The Commission has issued the enclosed Amendments Nos. 42 and 11 to Facility Operating Licenses Nos. DPR-51 and NPF-6 for Arkansas Nuclear One, Units Nos. 1 and 2 (ANO-1&2). The amendments consist of changes to the Technical Specifications in response to your application dated February 12, 1979.

The amendments modify the ANO-1&2 Appendices A and B Technical Specifications dealing with Arkansas Power and Light Company management organization structure.

SAFETY EVALUATION BY THE OFFICE OF NUCLEAR REACTOR REGULATION

SUPPORTING AMENDMENTS NOS. 42 AND 11 TO

Figure 6.2-1 Management Organization Chart

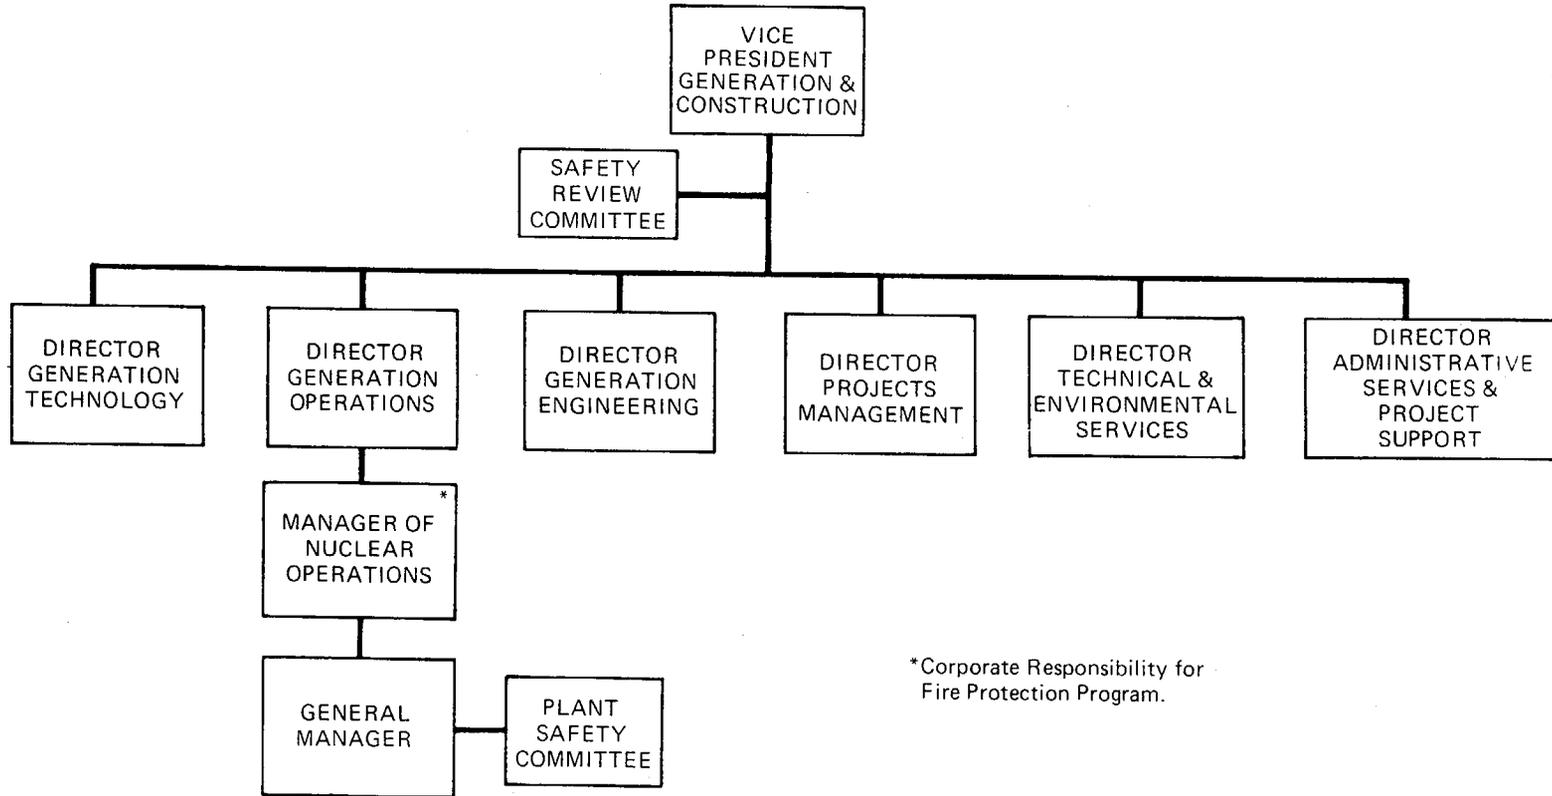
We have reviewed the proposed change to the ANO-1&2 Administrative Control Sections of the TS. The Executive Director, Generation and Construction, would be changed to Vice President, Generation and Construction. The functions and responsibilities of the new position are the same as those of the Executive Director, Generation and Construction.

We find the proposed change to be an administrative change; it does not decrease the margin of safety and is acceptable.

FIG. NO.
5-1

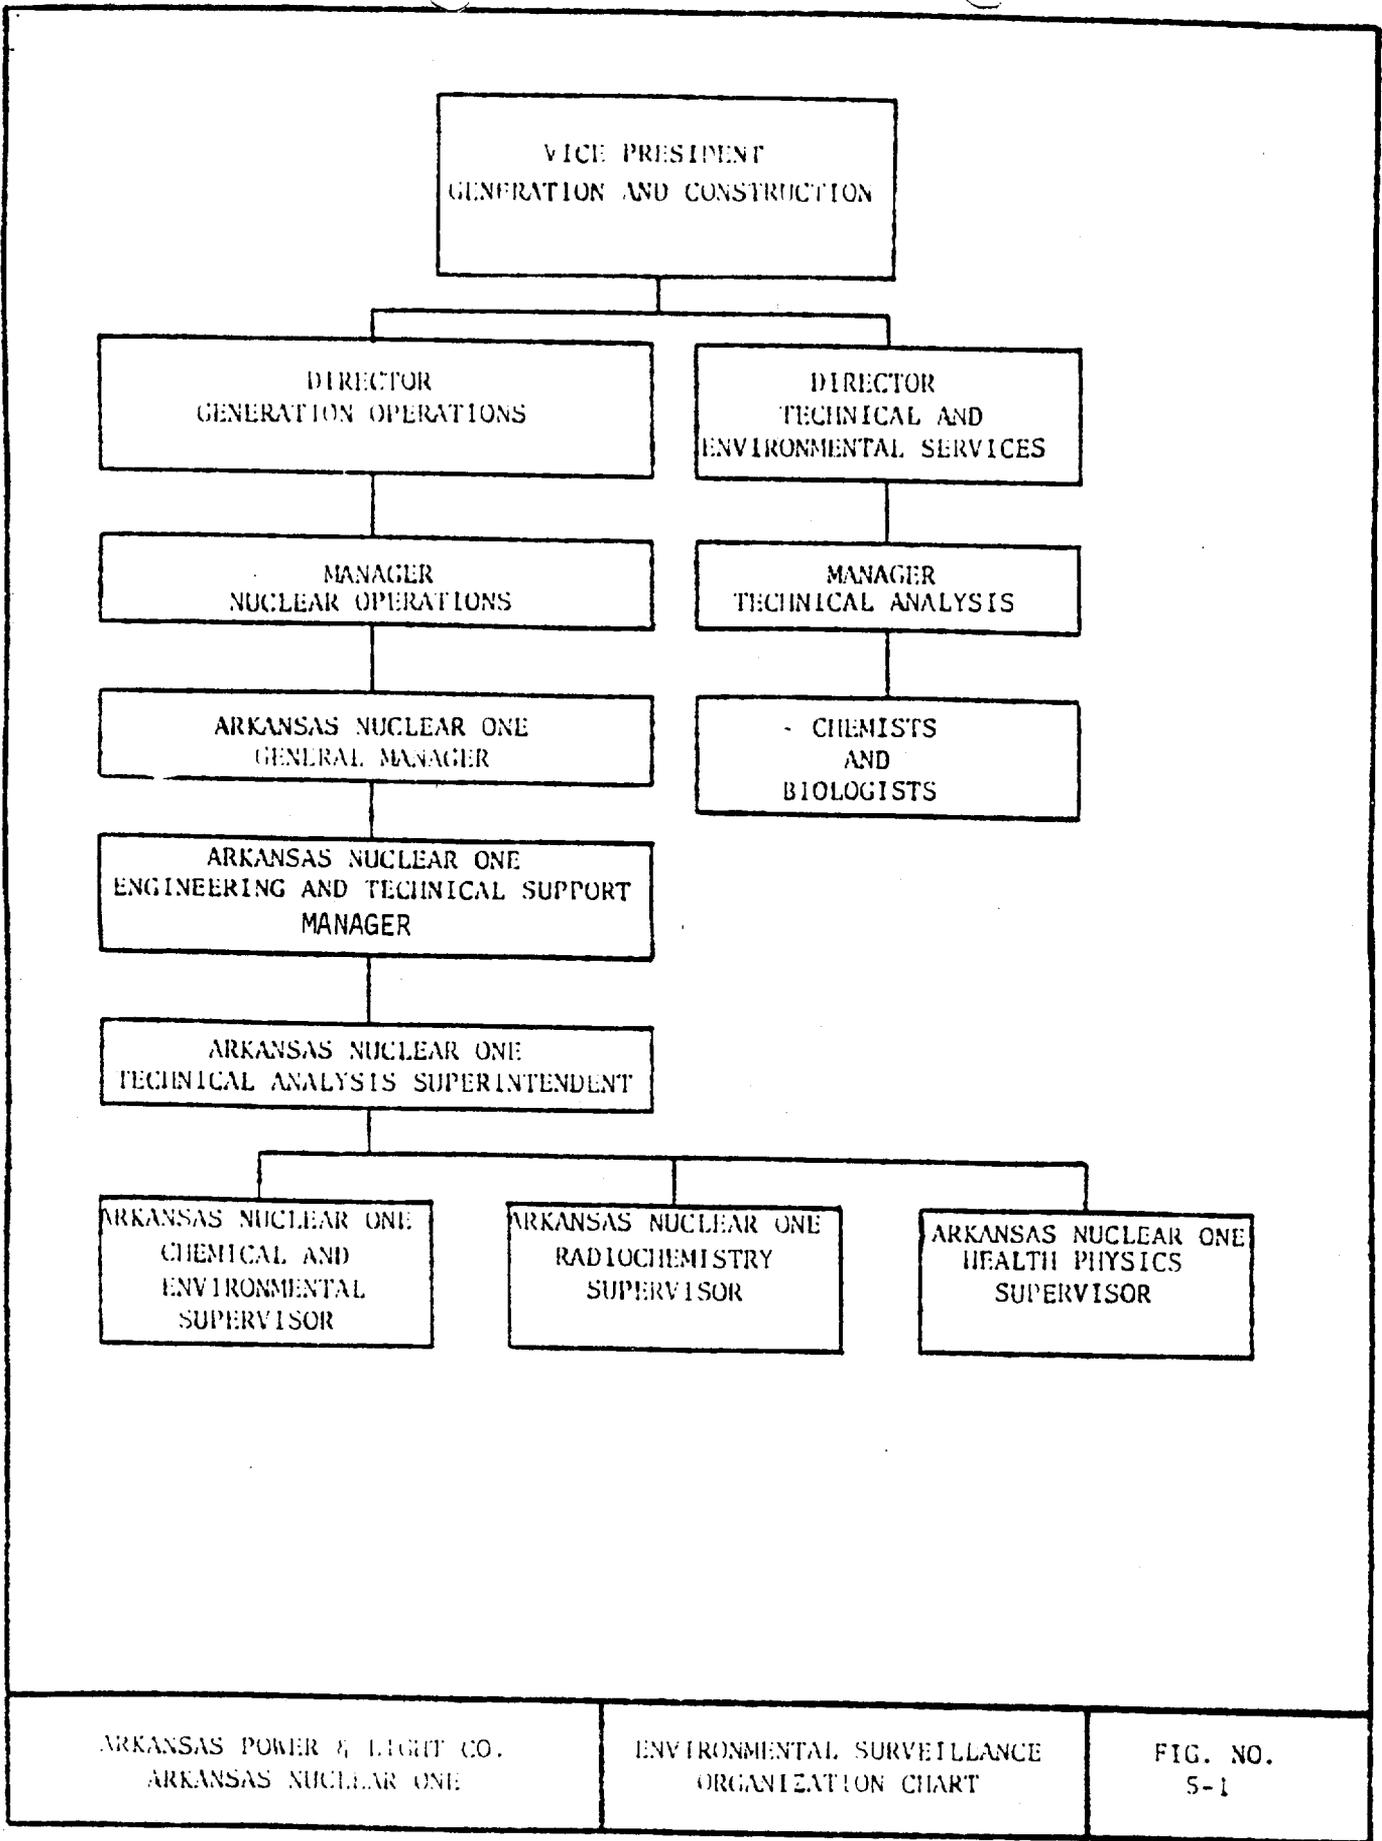
Corporate responsibility for implementation of the Environmental Technical Specifications, and for assuring that station operations are controlled to provide protection for the environment has been assigned to the Vice President, Generation and Construction.

FIG. NO.
5-1

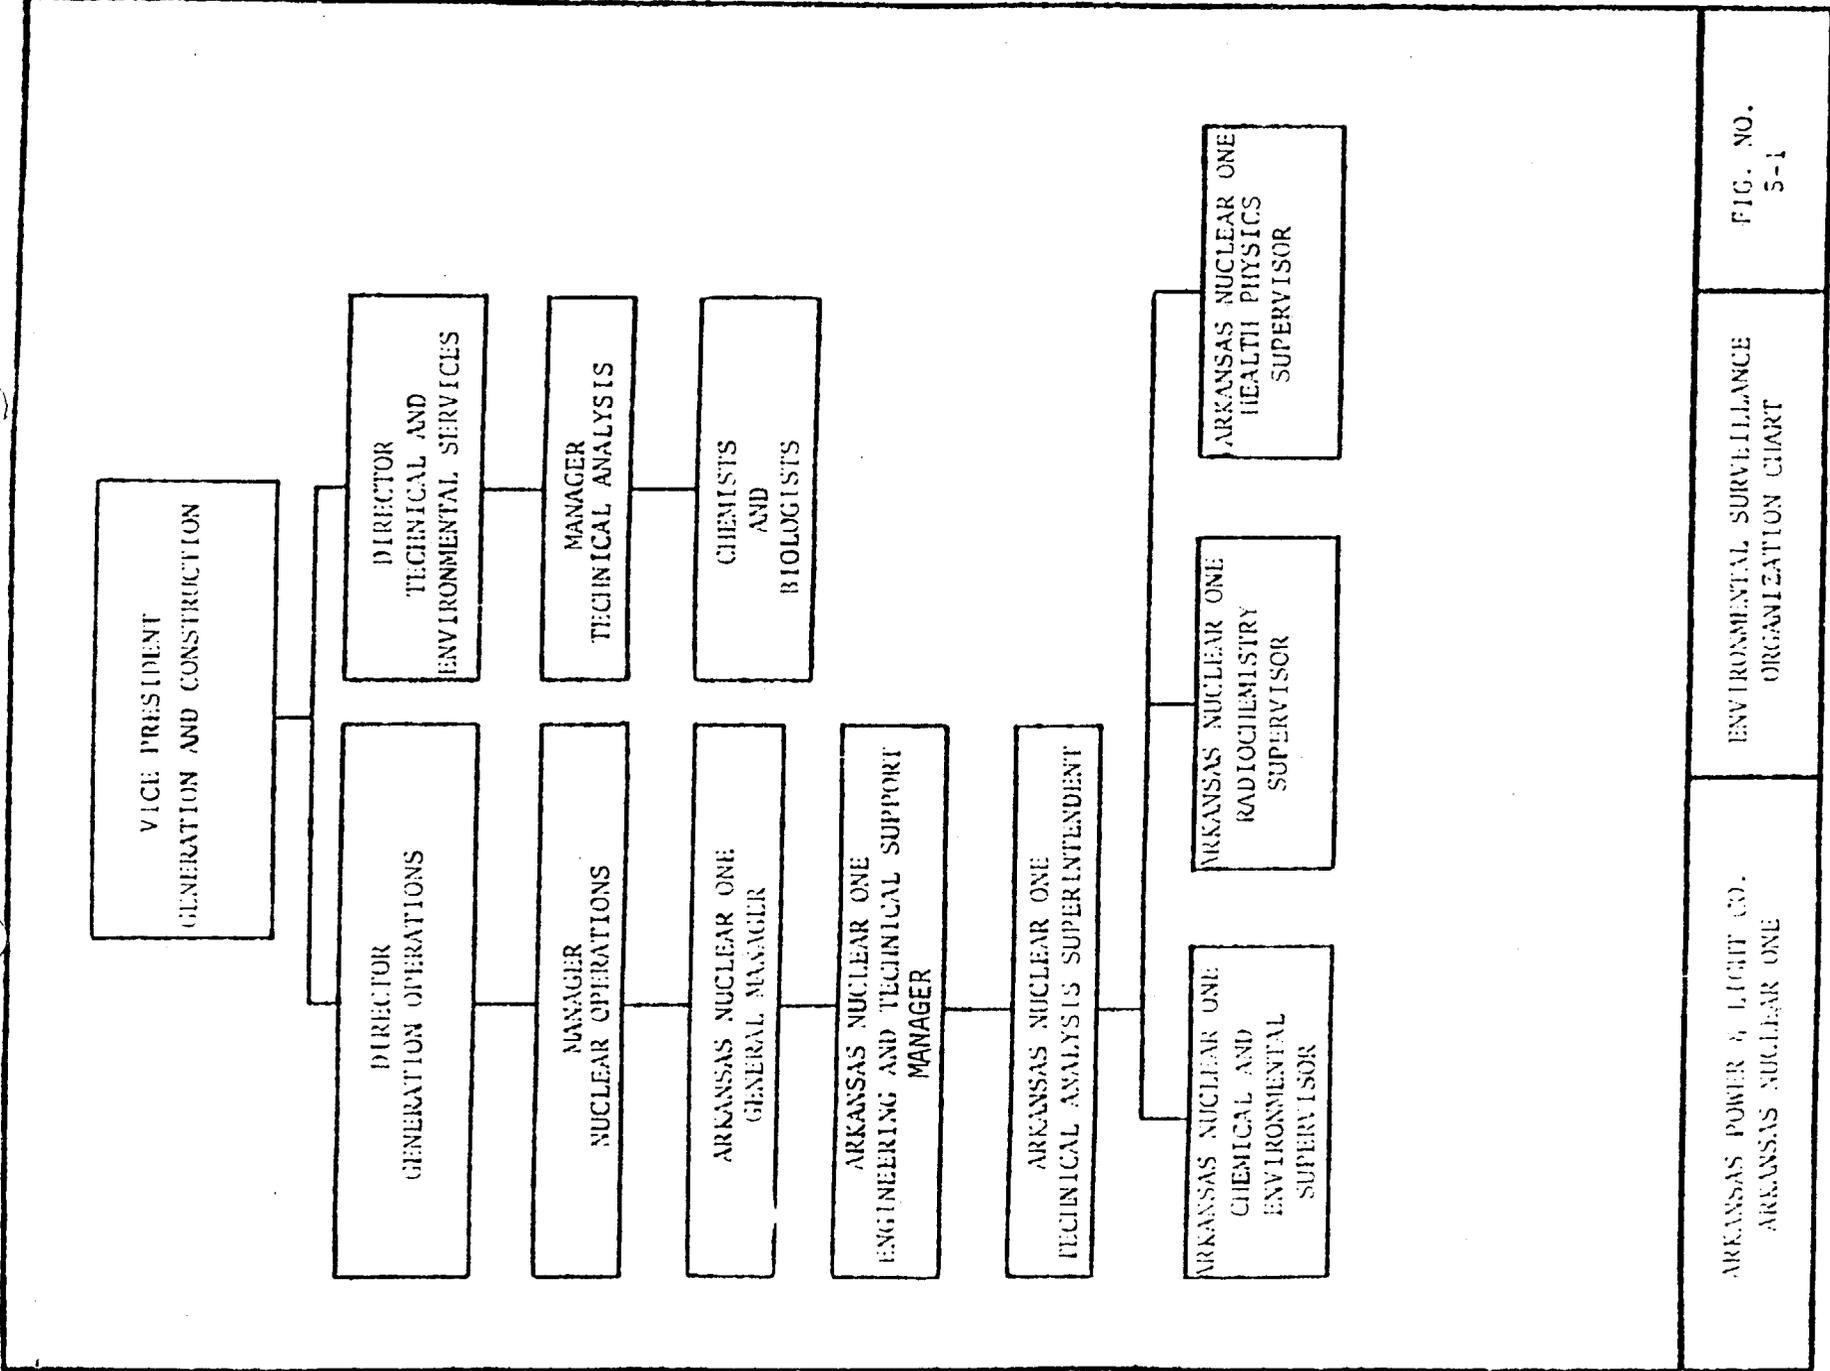
Corporate responsibility for implementation of the Environmental Technical Specifications, and for assuring that station operations are controlled to provide protection for the environment has been assigned to the Vice President, Generation and Construction.
